Subject: Soil/Site Evaluation Report
Mann's Chapel Rd, Chatham County Tax Pin 68308, +/- 12 Acres

Soil Map
Spoon
Chatham Co. Parcel# 68308
4 +/- 12 Acres
Jan 5, 2019
Project FR2019-1

From: Thomas Boyce <thomas.boyce@chathamnc.org>
Sent: Wednesday, July 3, 2019 12:28 PM
To: Kimberly Tyson
Subject: Hobby Farms

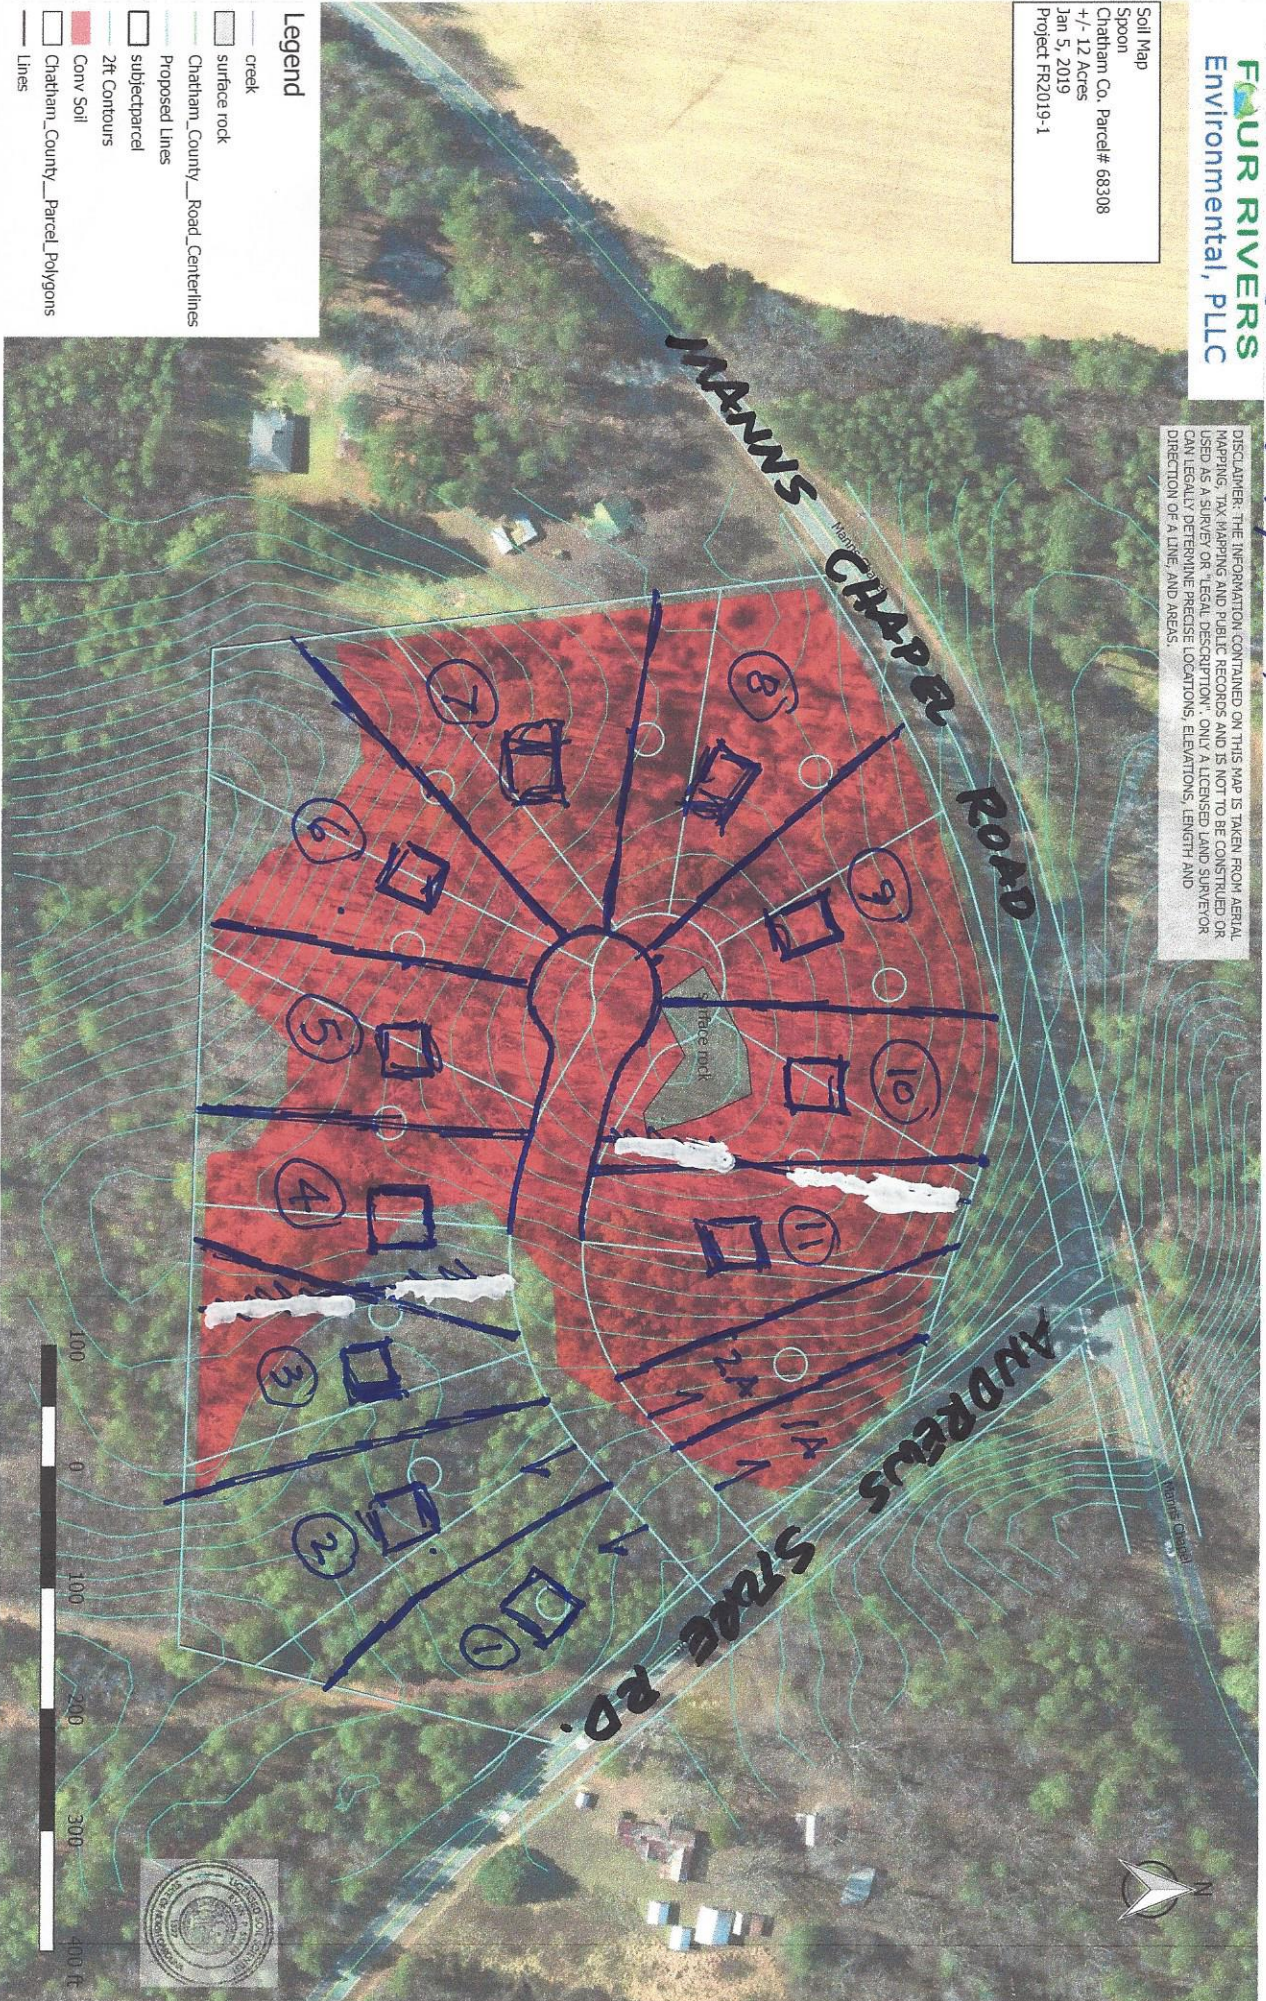
LOTS have to be 40,000 sq. ft. +
(with County water)

Check with NCDOT about this → ENCROACHMENT AGREEMENT - DOT

10 LOTS WOULD BE BETTER SHARED LOTS
